# ControlLogix ControlNet Interface Module

Catalog Numbers 1756-CNB and 1756-CNBR

These release notes describe changes in version 5.50 (series D) of the ControlLogix ControlNet Interface Module, catalog numbers 1756-CNB and 1756-CNBR.

Publication 1756-RN587H-EN-P - June 2005

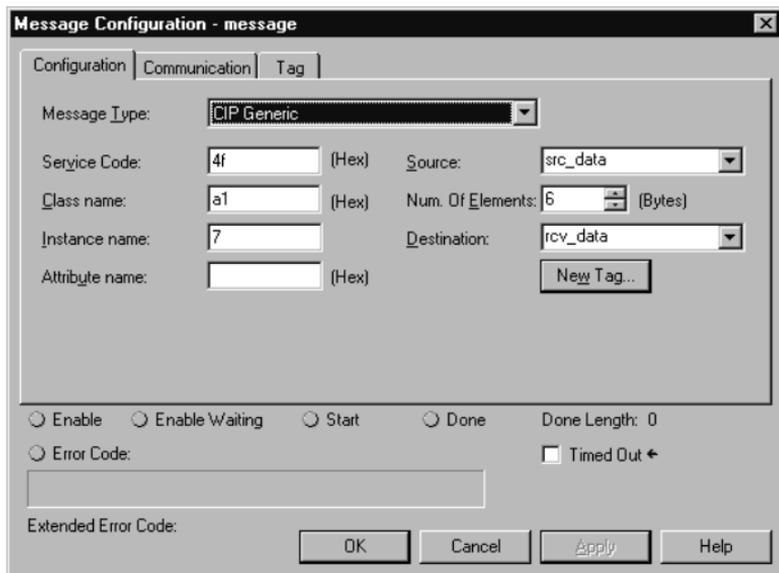
- We added the ability to present diagnostic information on the 4-char display on the module. This information can now be displayed:

Display	Description
n C # #	## indicates the total number of open connections Max = 64
n U # #	## indicates the total number of unconnected buffer usage Max = 20
% C # #	## indicates the module's CPU utilization percentage Max = 99%
B x # #	## indicates the number of bandwidth exceeded occurrences since the last module reset Max = 99 Note: This counter display is disabled until the module detects at least one bandwidth exceeded event

Display	Description	
K p # #	Keeper status	
	If # # equals:	The module is:
	Ov	Offline with valid keeper information
	Oi	Offline with invalid keeper information
	Av	An active keeper
	Ai	An active Invalid keeper
	Iv	An inactive valid keeper
	Ii	An inactive invalid keeper

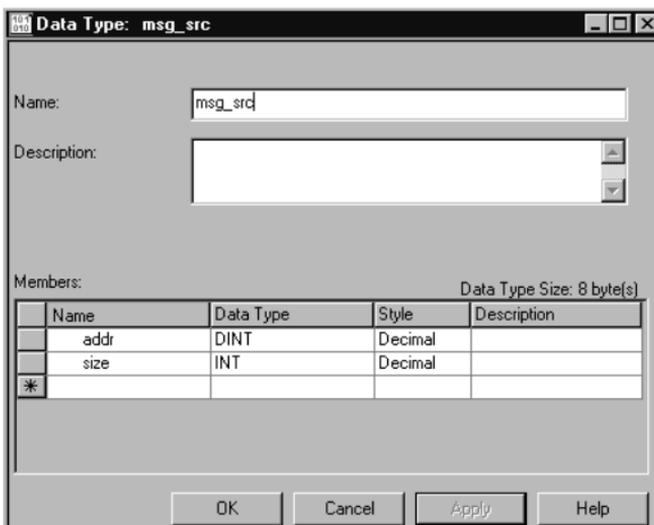
The following is an example of how to set up a CIP Generic MSG to display these diagnostic counters. Fields that are not associated with any captions must be configured exactly as shown.

Source Tag configuration: The source tag used in the above MSG instruction must be a User Defined Tag consisting of a DINT and an INT.

This figure shows what that User Defined data type looks like.

To display diagnostic counter information, the user must put the appropriate value that associates with the address of the diagnostic counter into the DINT portion of the source tag and the value associated with the size of the counter into the INT portion of the source tag. When the message is executed with the appropriate counter configuration, the assigned diagnostic counter value will be written to the destination tag (in the above example: rcv\_data).
